REMARKS

Applicant: Lee et al.
Application No.: 10/617,335

Fig. 4

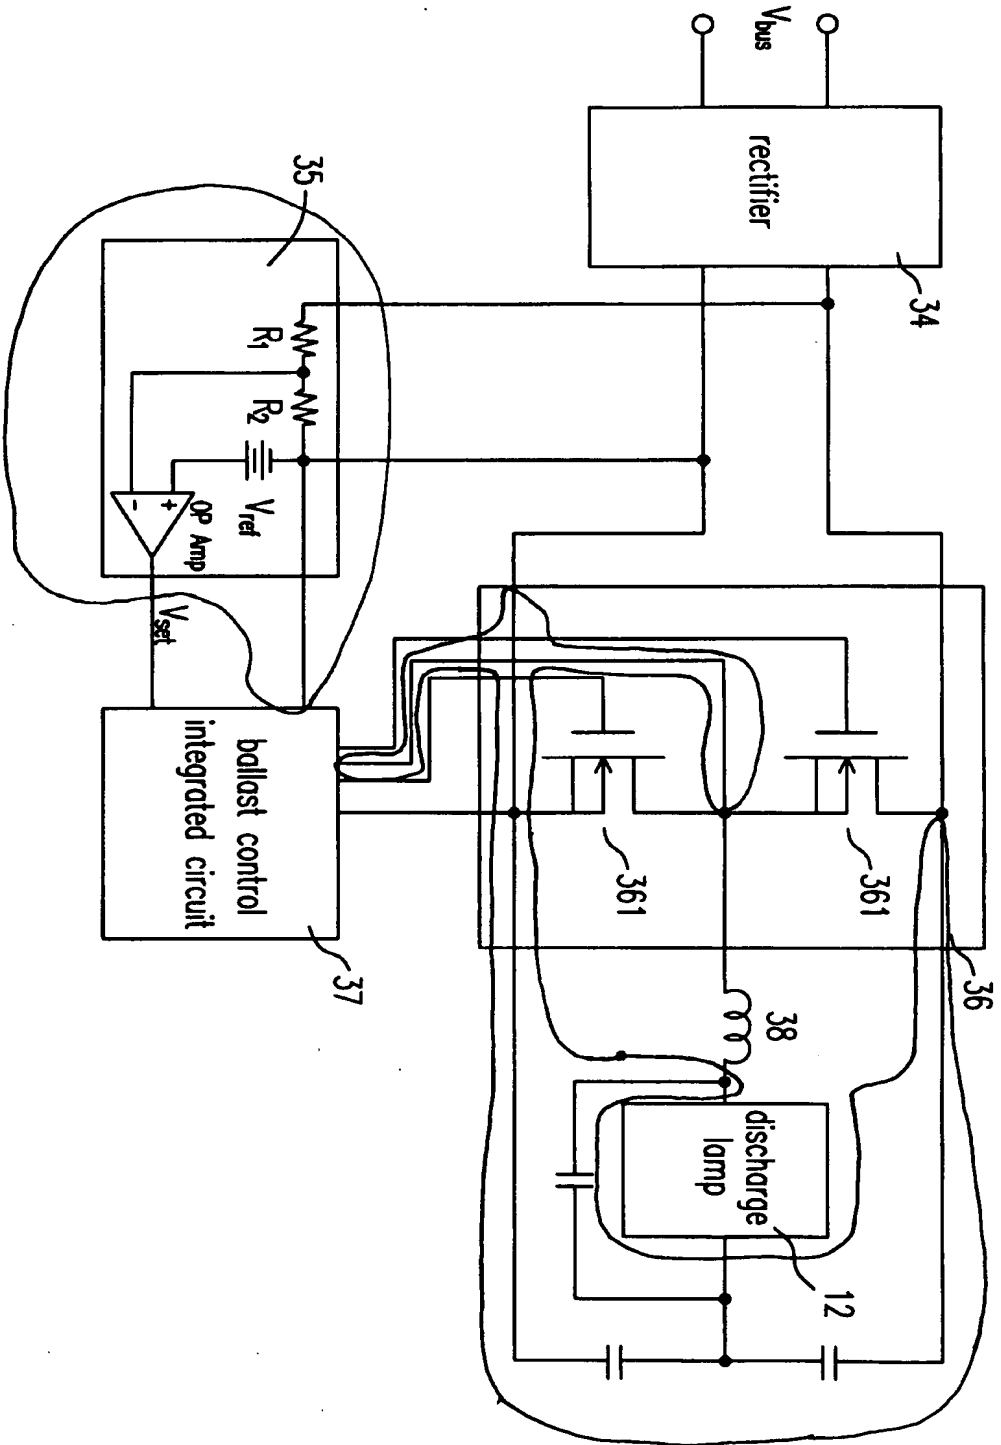
The esteemed examiner considered that the 'operational amplifier' recited in line 2 of Claim 7 must be shown. The Fig. 4 is modified according to the esteemed examiner's opinions etc. as described above.

In Fig. 4, the voltage converter 35 is modified to show that the voltage converter 35 includes an operational amplifier and other elements as disclosed in the amended claim 7 according to the esteemed Examiner's opinion. Further, extra connecting circuits among voltage converter 35, the inverter 36, the ballast control integrated circuit, and the discharge lamp 12 are modified and three capacitors (one for the resonant LC circuit and two for the half-bridge circuit, which all are elements of the ballast circuit known in the prior art) are added in Fig. 4 so as to show the configuration of the proposed dimming control system in more detail such that the unique features of the present invention can be fully understood.
